Responses to Design Review Report and Decision

January 29, 2025

DSRFY2024-0018
Ozzy's Car Company
112 W. 42nd Street
Garden City, ID 83714

A1.00

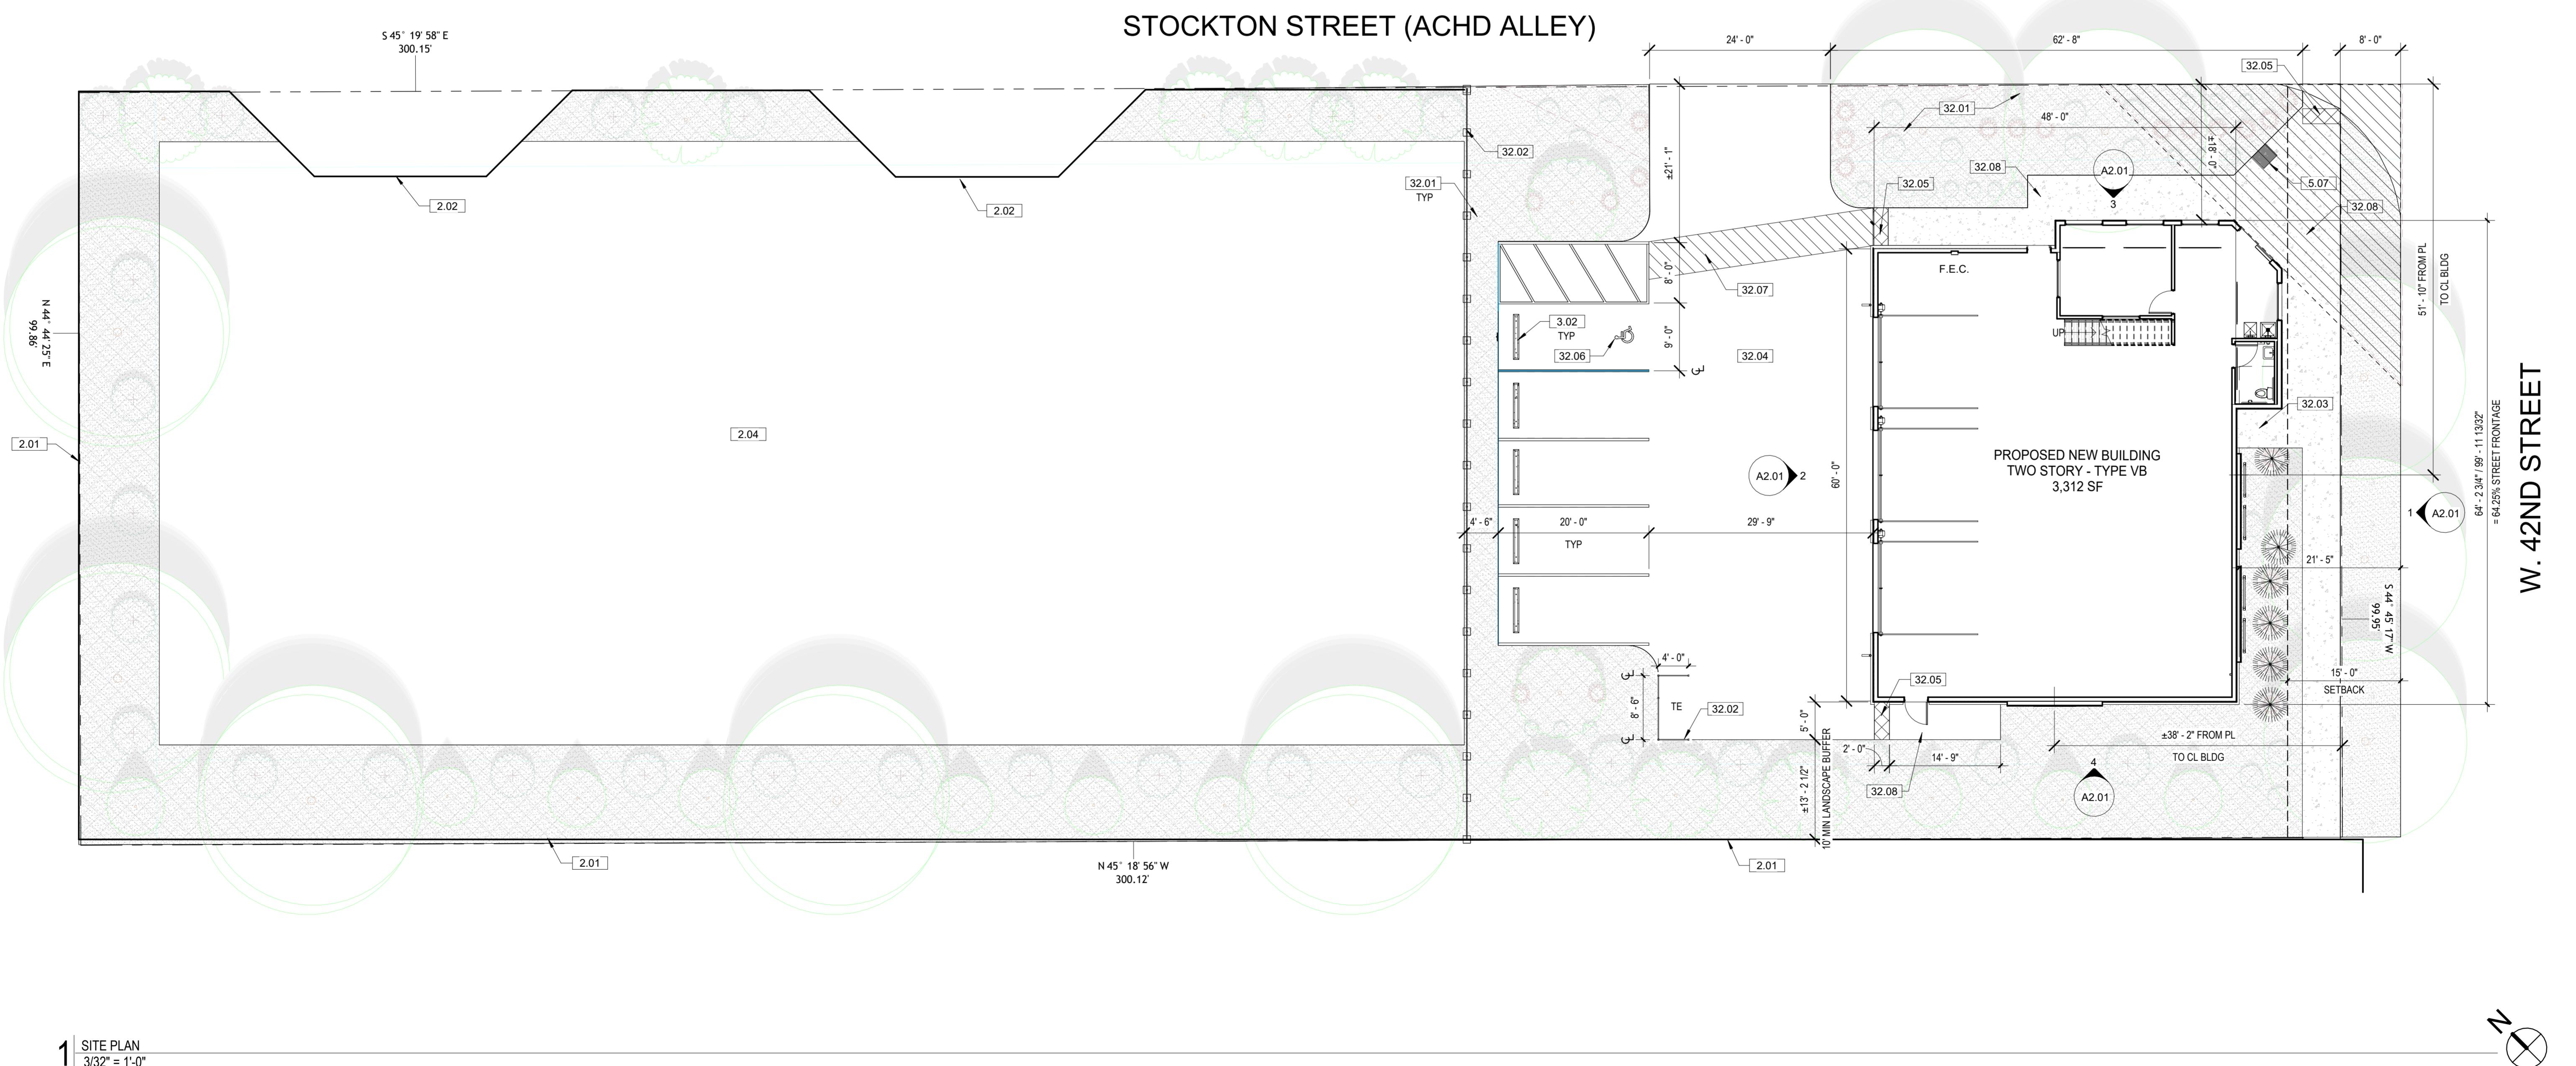
The applicant plans to place a trash enclosure on the northern site border for alley service, screened by a 6' tall metal fence. Clarifications needed.

All on-site service areas for waste, recycling, or trash; and equipment areas for transformer and utility vaults shall be located in an area not visible from a public street or adjoining property, or shall be screened from view from a public street and adjoining property with a privacy fence.

Privacy fence is a fence that is constructed of solid or opaque materials through which no views can be seen.

Trash enclosure for carts relocated to rear of parking lot with privacy fencing.

Comment:

Based on the resubmittals received on 12/03/2024

A minimum of five percent (5%) of the gross site area shall be landscaped areas, excluding areas for setback or perimeter landscaping.

Refer to the updated Landscape Plan for updated calculations and additional trees.
